From: Michael Eastham
Sent: 29 September 2017 12:39
To: Planning.Responses
Subject: FW: Stage 1 Road Safety Audit - Development proposals at Land adjacent to Water Lane, Angmering

ROAD SAFETY AUDIT RESPONSE REPORT

A280 / A27 / TITNORE LANE ROUNDABOUT PROPOSED IMPROVEMENTS ROAD WIDENING OPTION

STAGE 1

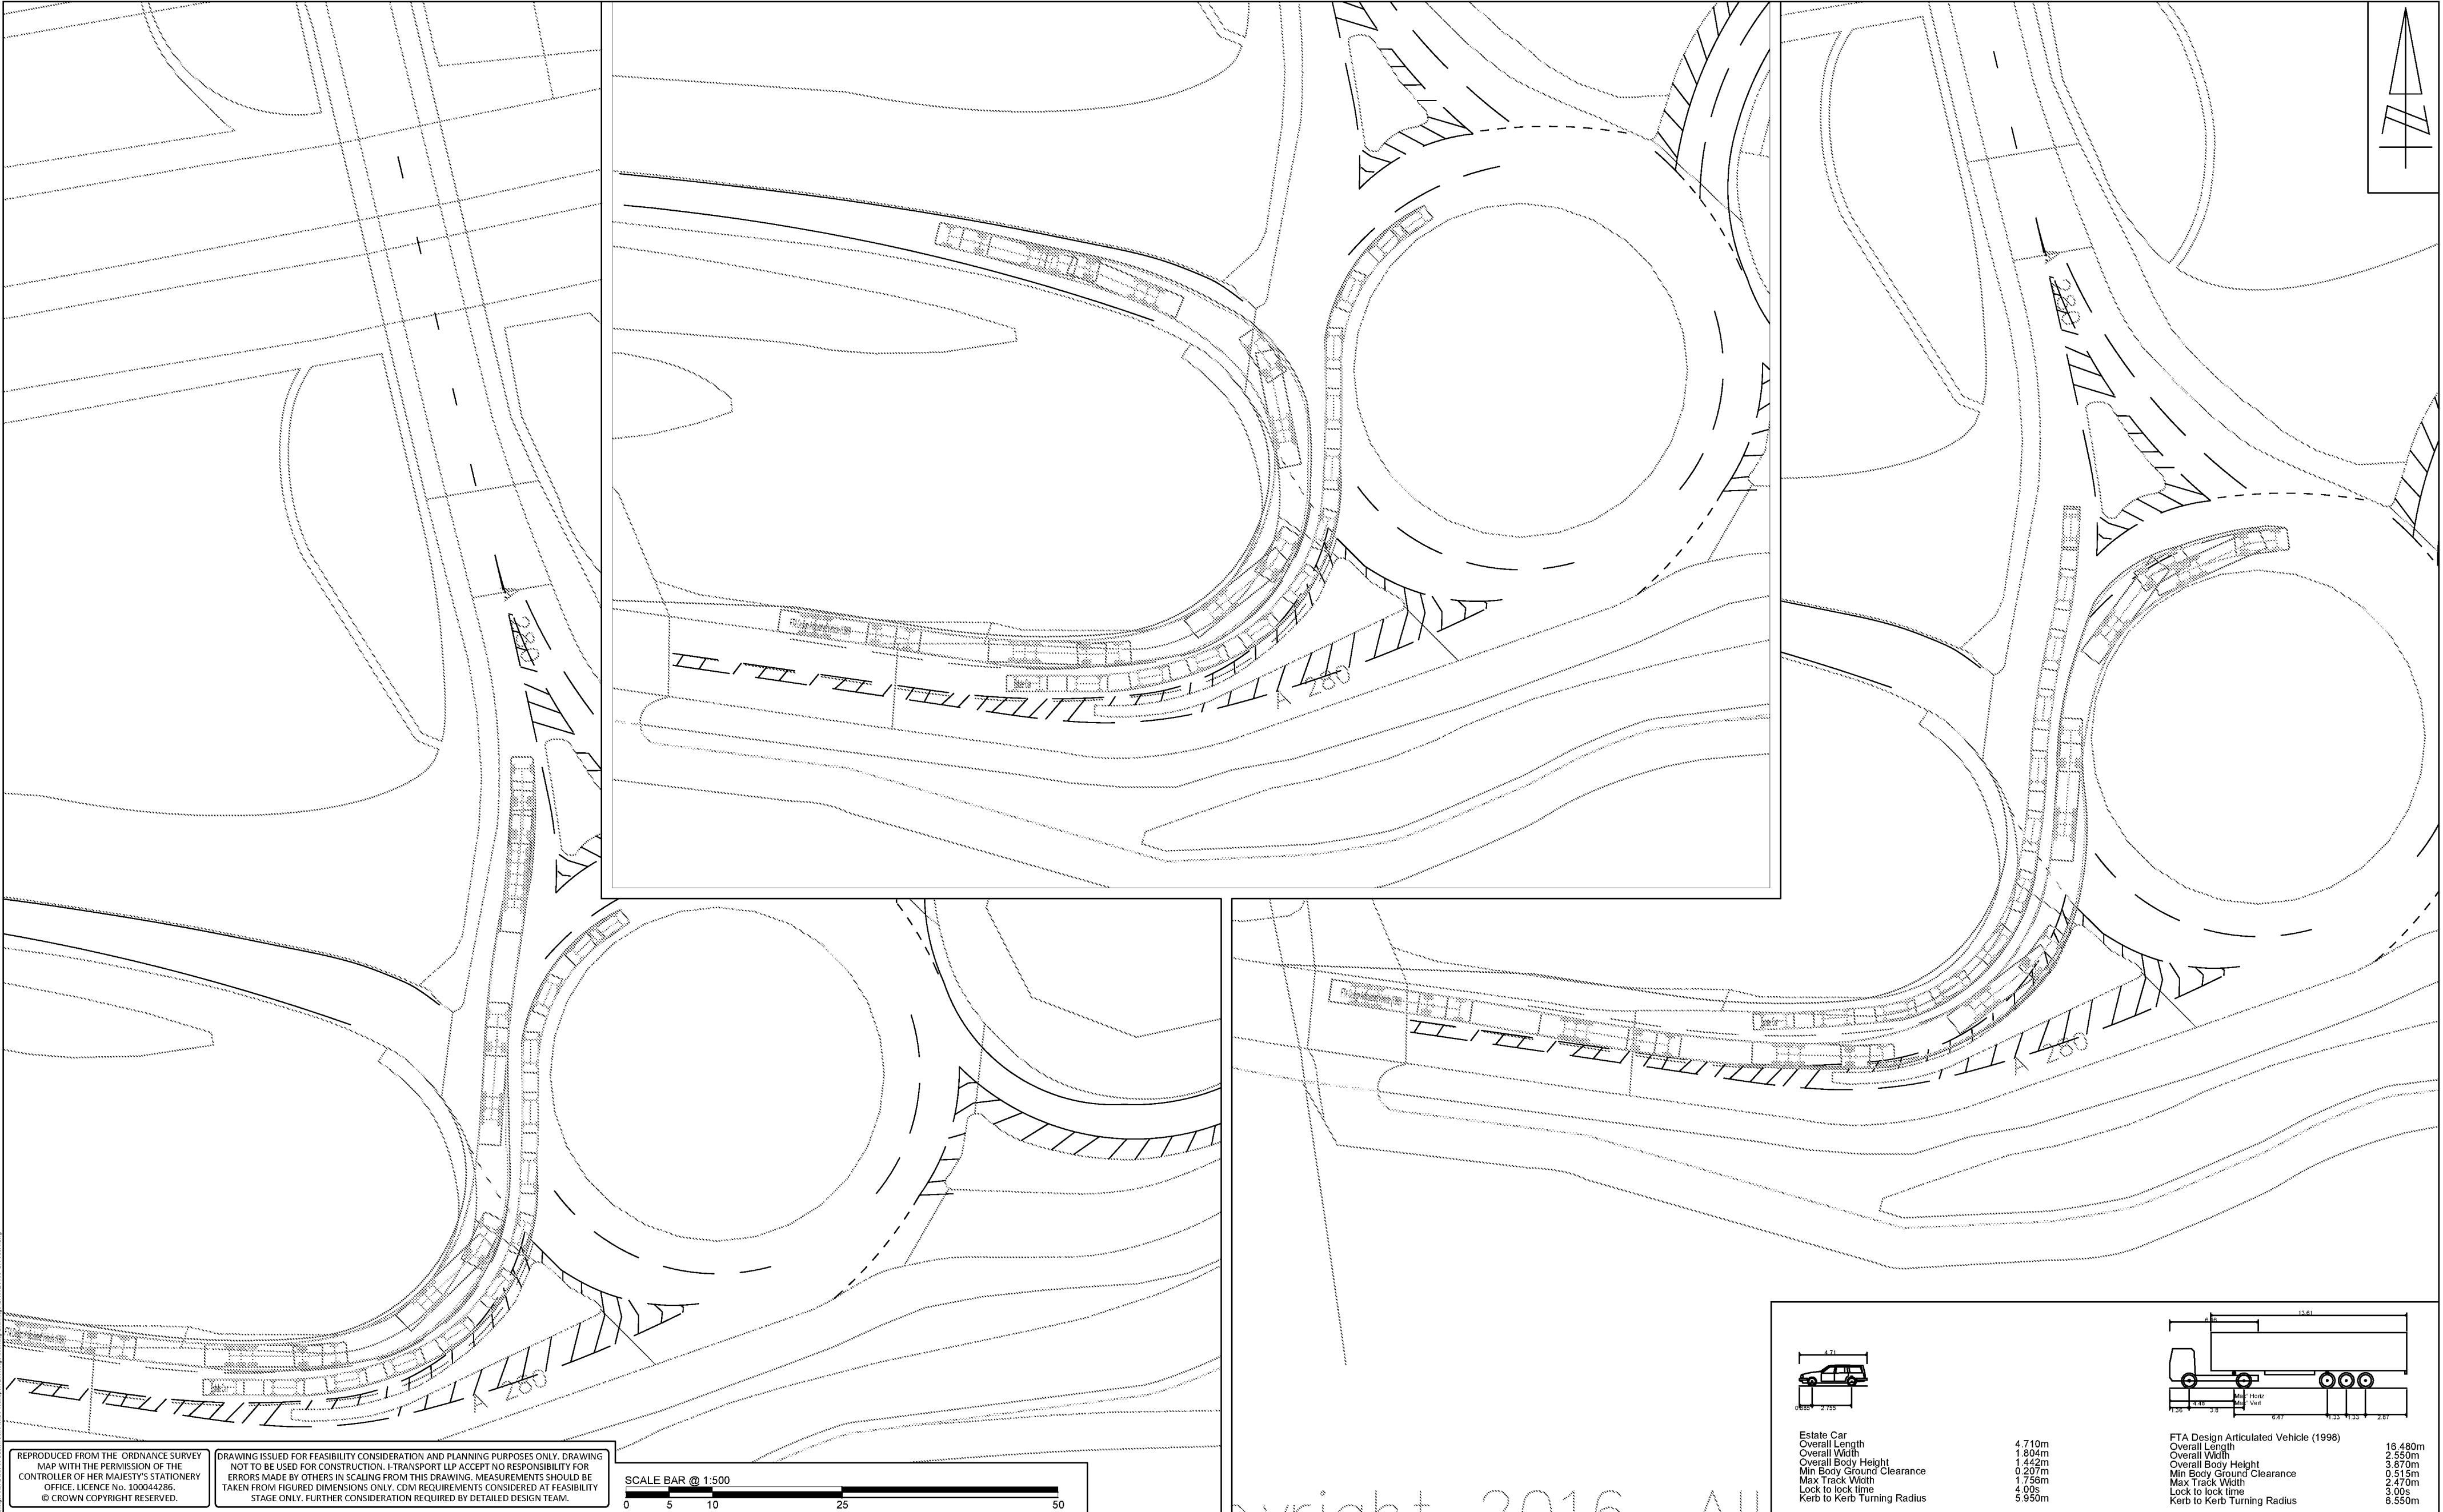
The proposed widening scheme will allow cars and other smaller vehicles to access lane two on the approach to the roundabout alongside articulated HGVs in lane one. The swept path analysis shows HGV's will require to enter lane 2 when positioning themselves on the approach to the roundabout in order to access the first or second exits from the roundabout. This will increase the risk of side swipe type collisions or vehicles in lane 2 having to brake heavily risking tail end shunts when the HGV swings into lane two to manoeuvre for access.

Agreed – To reduce the risk of side swipe type collisions the approach has been realigned to allow cars to pass an HGV's safely. This has been provided on Drawing ITB9105-GA-024 Rev B. Swept path analysis has been undertaken to demonstrate that a car can pass an HGV safely as illustrated in Drawing ITB9105-GA-035 Rev A.
